## **Falcon Highlands South**

### **Preliminary Drainage Report**

**August 26, 2022**

**PUDSP-22-005**

CHALLENGER HOMES  
FALCON HIGHLANDS FILING NO. 3  
EL PASO COUNTY, COLORADO  
DRAINAGE MAP  
MAJOR BASINS PROPOSED CONDITIONS

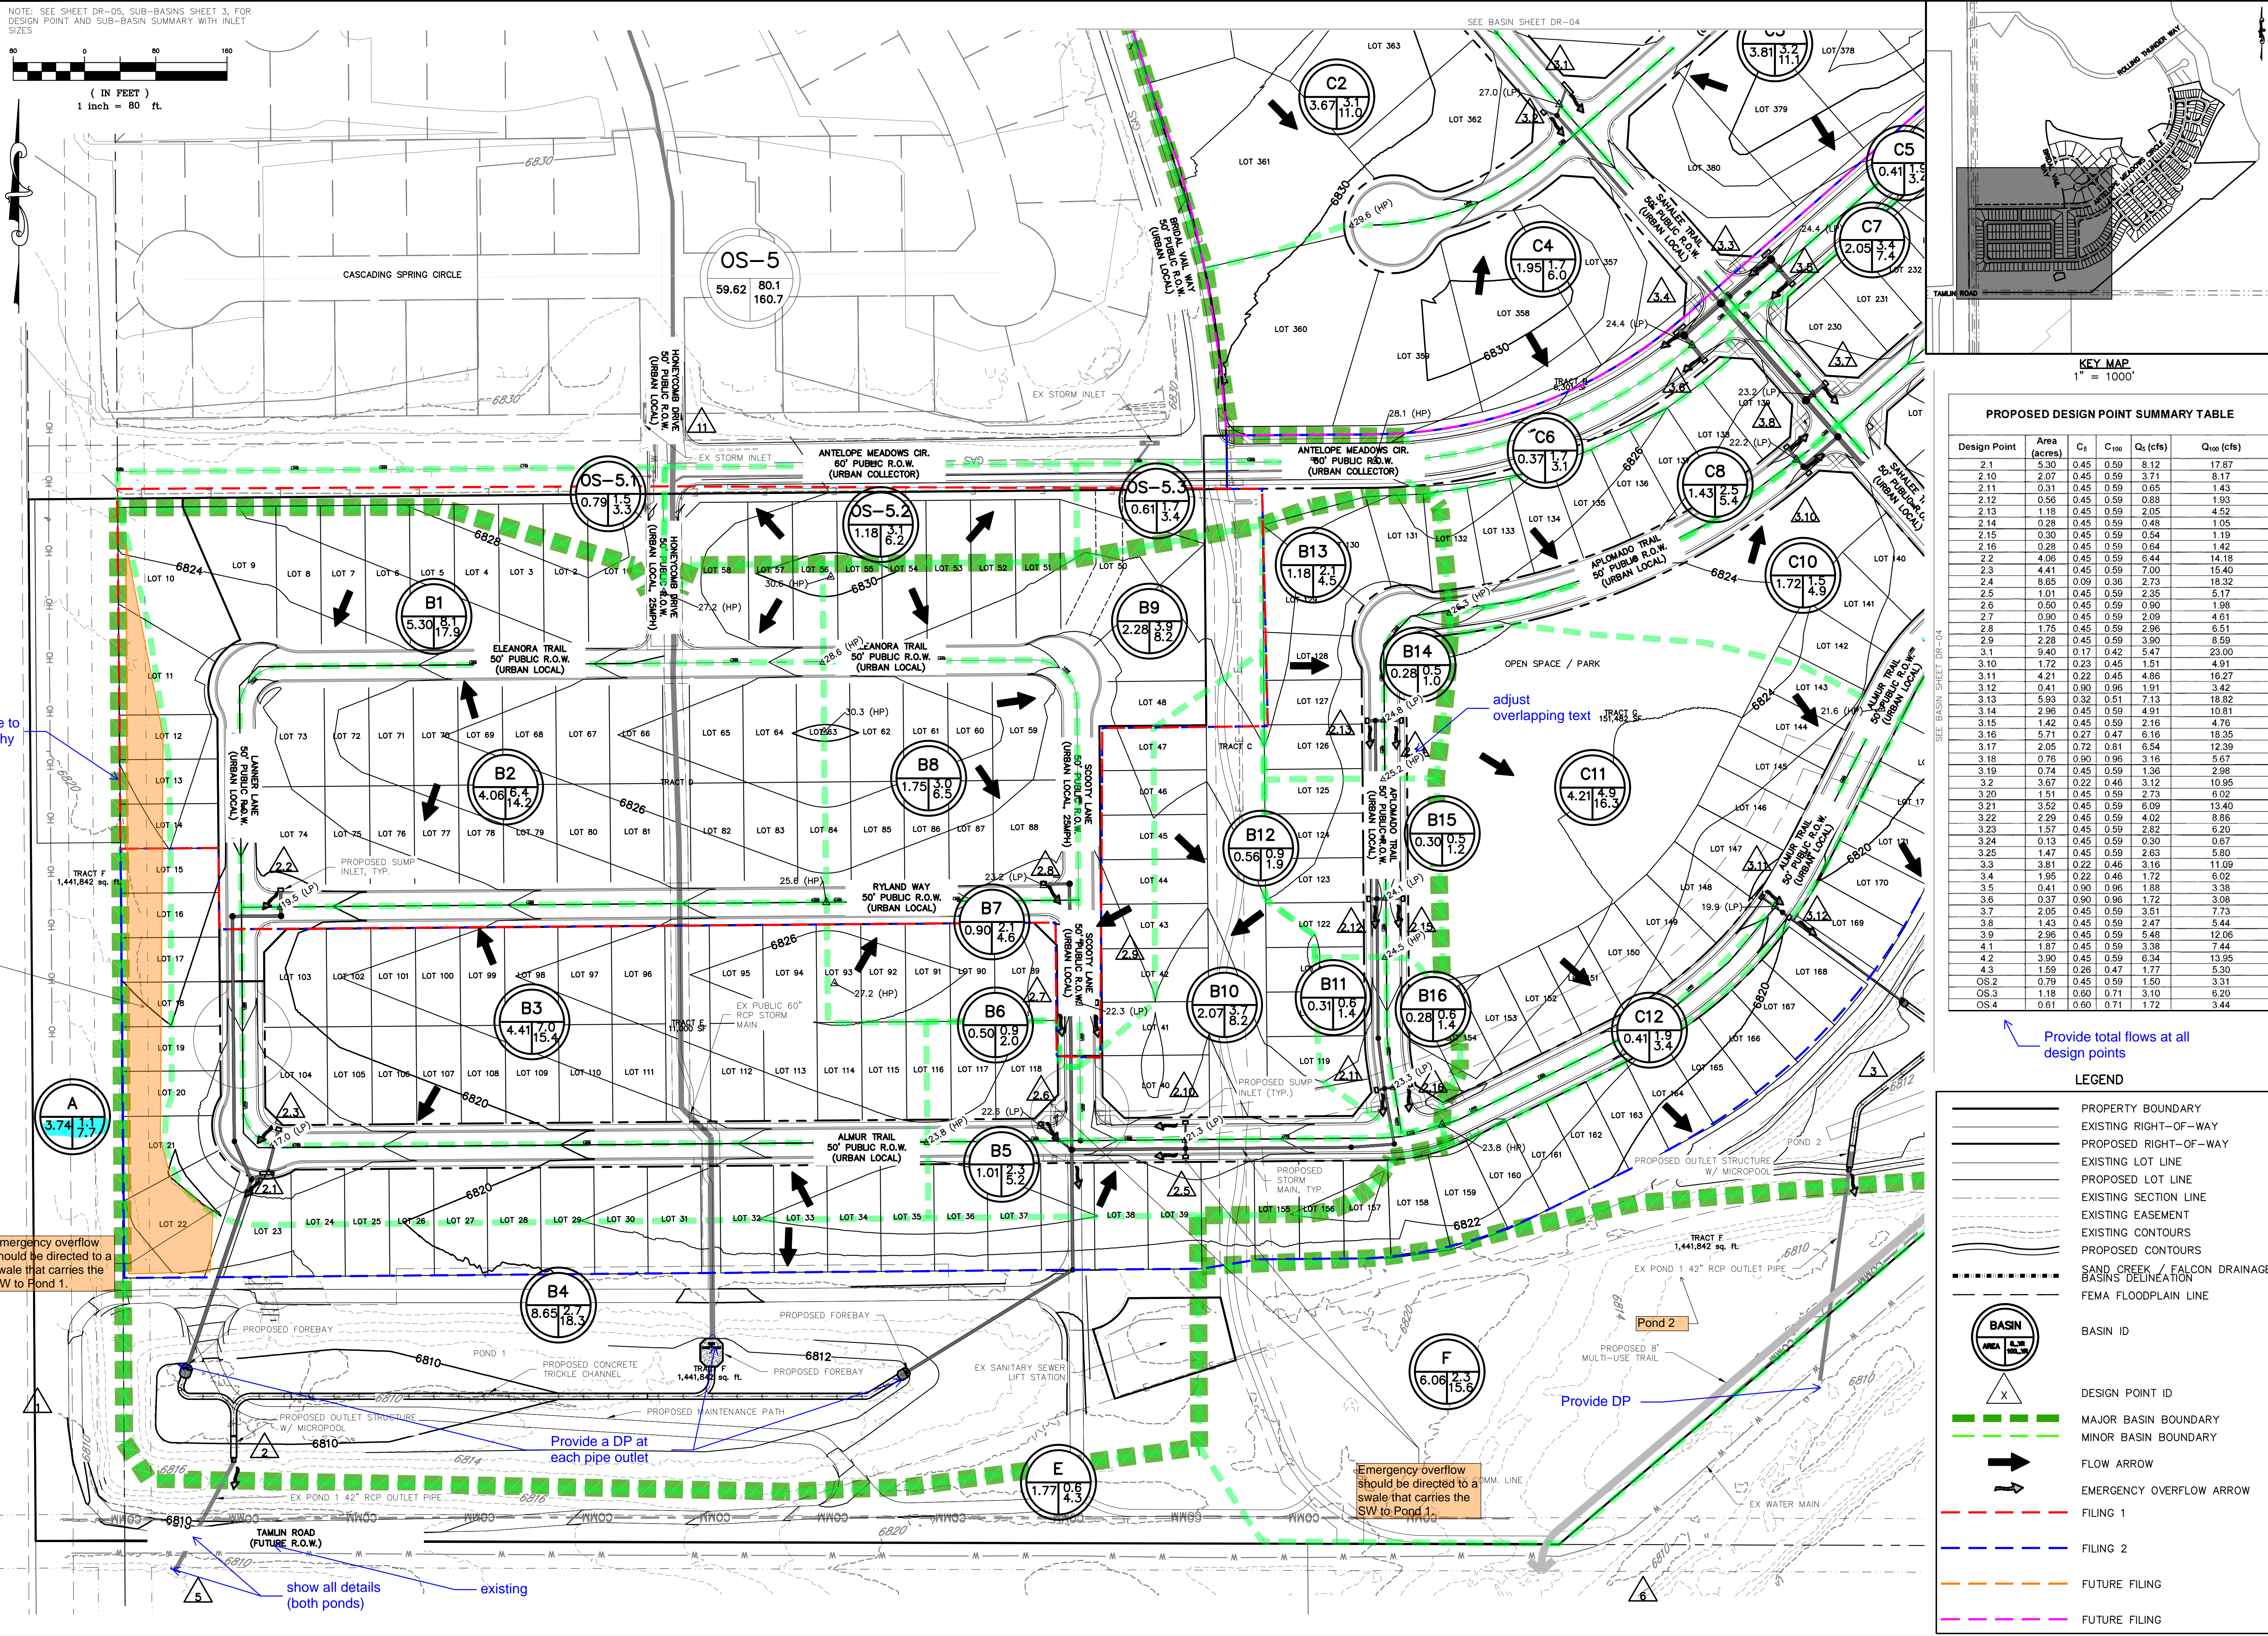
Show Tamlin Road ROW on all plans

Provide total flows at DPs also

**CHALLENGER HOMES**  
FALCON HIGHLANDS FILING NO. 3  
EL PASO COUNTY, COLORADO  
DRAINAGE MAP  
SUB-BASINS  
SHEET 1

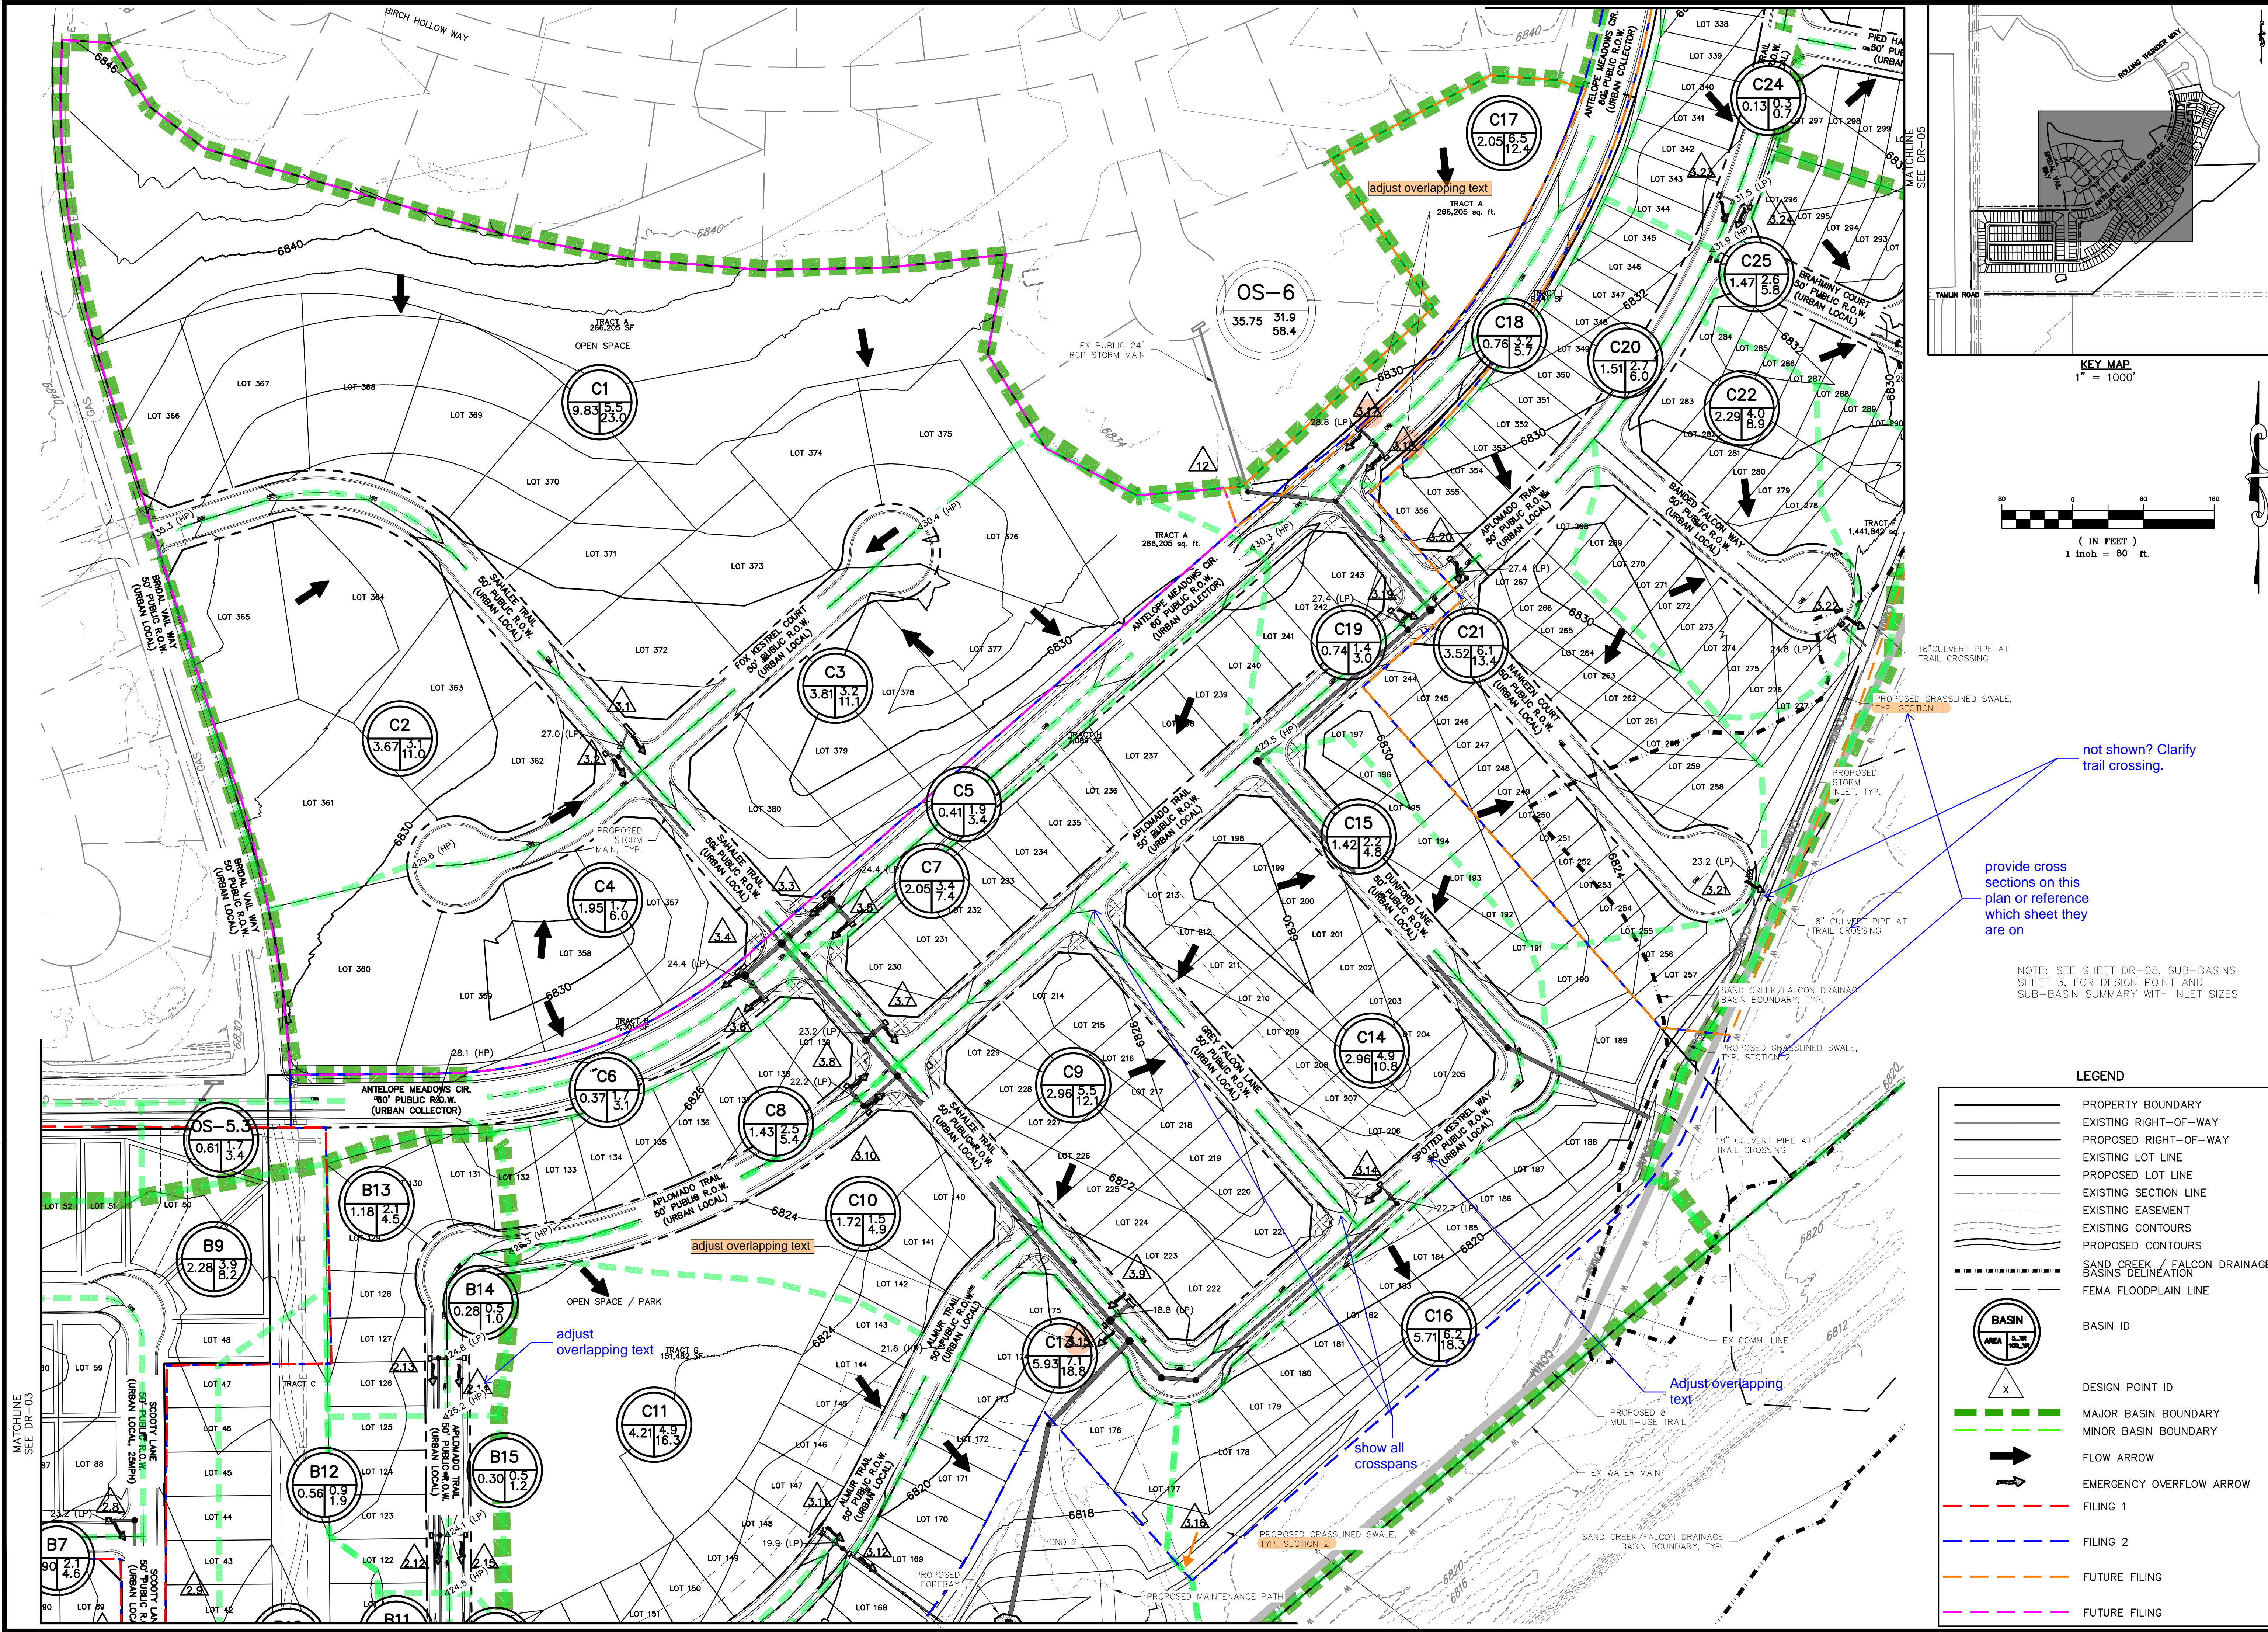
Emergency overflow should be directed to a swale that carries the SW to Pond 1.

Provide a DP at each pipe outlet

show all details (both ponds)

adjust overlapping text

Provide total flows at all design points

Provide DP
